Groceries Online (GOL) Facility - Uxbridge

Noise Assessment

Appendix C – Anderson Acoustics Comments and Response Document

Figure 1 3D image of CadnaA model showing noise source locations

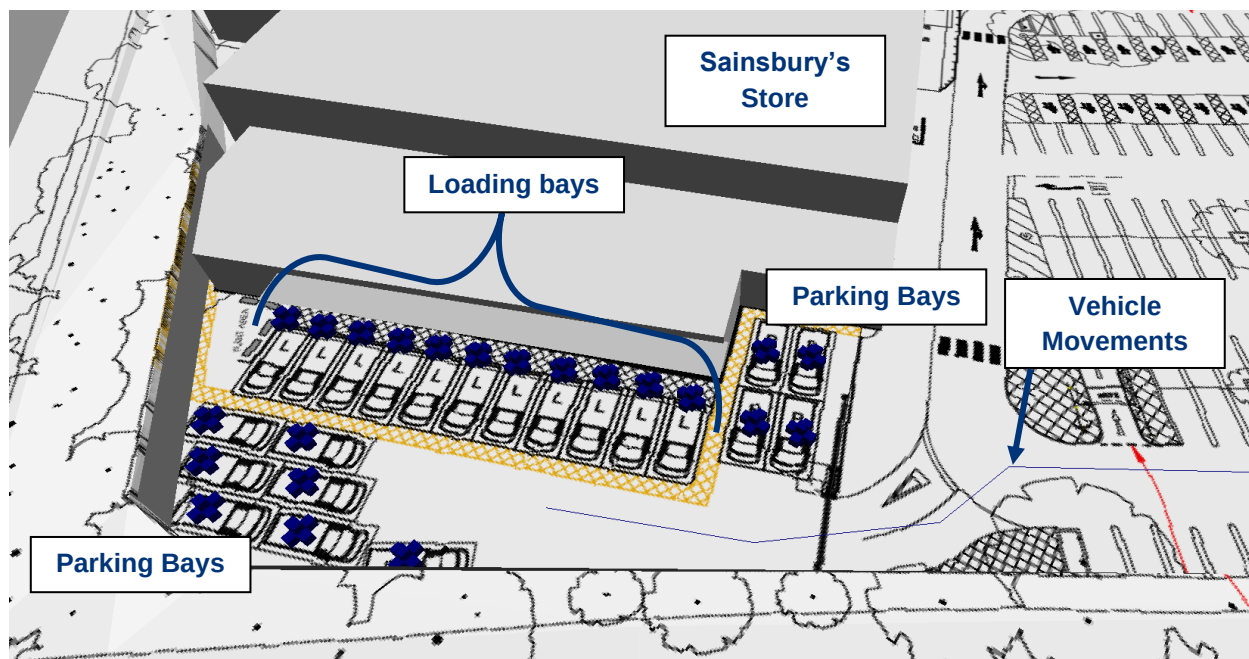
The Assessment Methodology is updated to clarify the provenance and selection of source values and how they have been used in the model. It is considered that further thought is given to the approach to the early morning scenario: how “100% unloading capacity” has been interpreted and modelled.

The source input data used for the assessment is taken from measured levels of an operational GOL facility the Sainsbury's store at Pontypridd. The assessment undertaken for this store was actually for a jet wash facility (planning application 12/0207/10) where the WYG-branded report is available online. However, whilst undertaking the baseline noise survey, source measurements of the operating GOL facility were undertaken to inform future modelling of proposed Sainsbury's GOL facilities and are considered to represent robust source noise levels associated with activities within GOL service yards, with the assessment assuming all parking bays and unloading bays are operating simultaneously.

With regards to the morning scenario, the assessment assumes that all 11 unloading bays would be in use at the same time during this early morning period. This has been modelled using point sources, with Figure 1 below detailing the location of these as well (as the parking bays and vehicle movements); for completeness, the overlain architect's plans are also shown.

Figure 2 Noise Contour Plot (Daytime) $L_{Aeq,1hour}$ – Grid Height 1.5m**AA Comment 7**

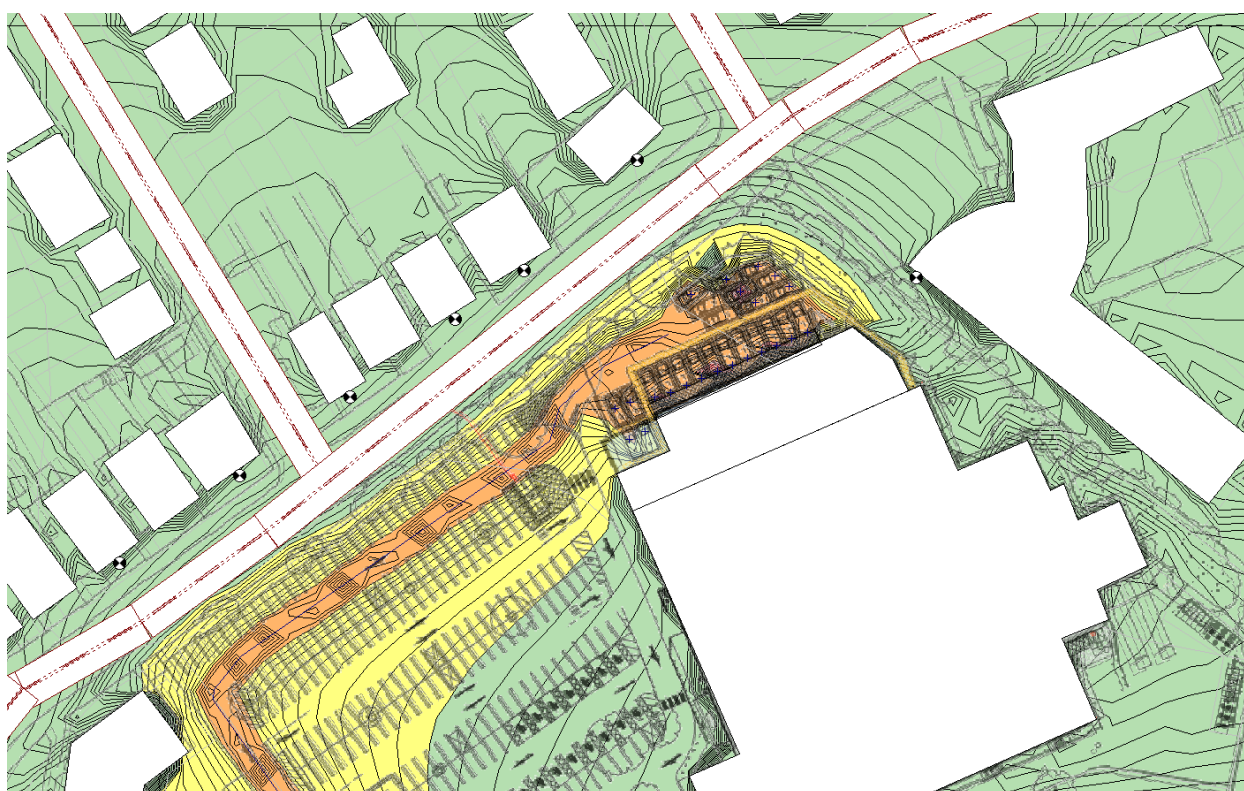
Use of the figure presented on the front cover within the main body of the report to show more clearly the scheme in relation to the receptors.

Although Figure 3.1 within the submitted noise assessment illustratively shows the proposed GOL area with respect to the assessed sensitive receptor locations, Figure 3 below presents the operational noise contour plot with the proposed site plans overlain, showing the locations of the respective sources.

Figure 5 Daytime Background L_{A90} Levels for LT1 (used for R01 and R02)

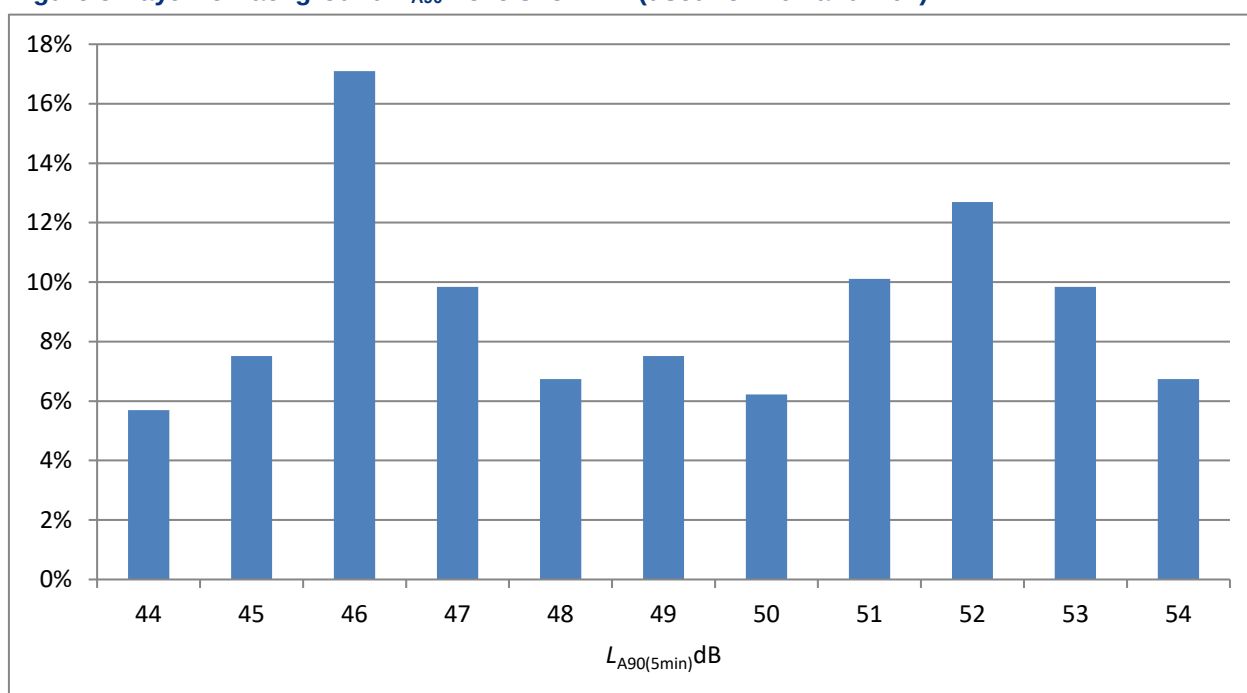
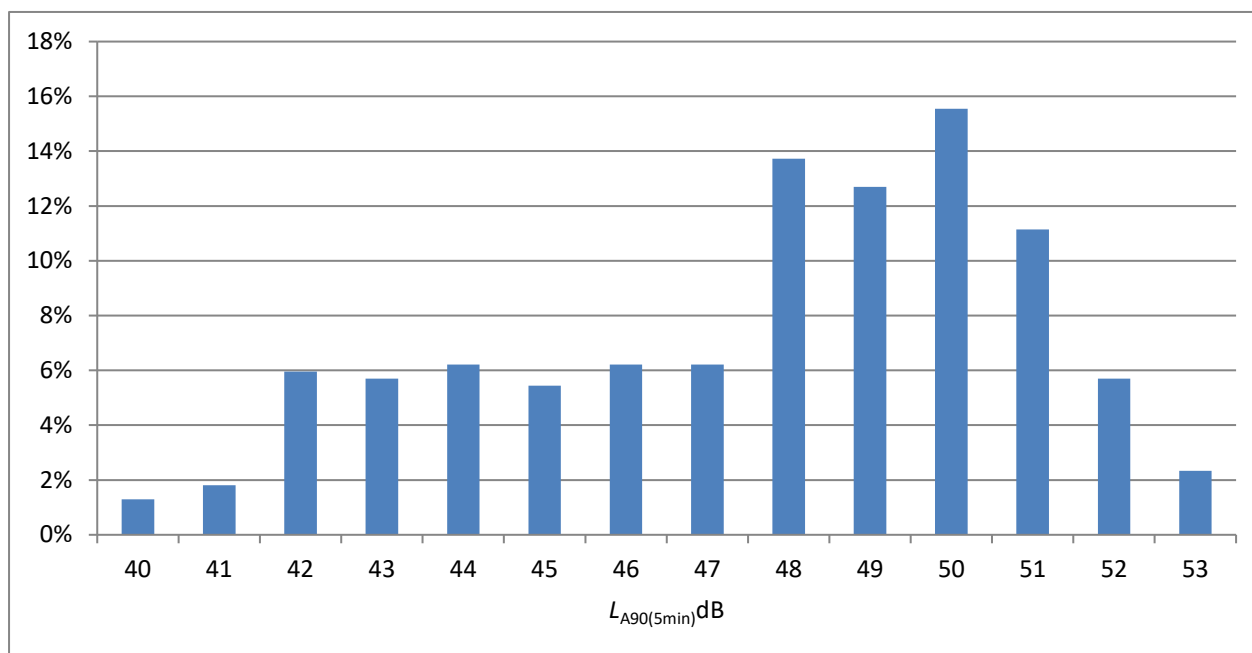
The Noise Survey section is updated to provide further details of the survey (including photographs) and the data, with discussion provided to show full understanding of the results and justification for the selection of the adopted background and ambient levels. Reference should be made to the advice in BS 4142 as to the selection of representative background levels.

As shown above, statistical analysis of daytime background levels shows that a noise level of 46 dB for LT1 and 50 dB for LT2 are representative of background noise levels during the daytime period, in-line with the guidance presented in BS 4142. To determine the evening (19:00-23:00) and early morning (06:00-07:00) periods, an hourly breakdown of L_{A90} levels was undertaken for LT1 and LT2 and the average for these time periods were taken to determine the background L_{A90} for these periods.
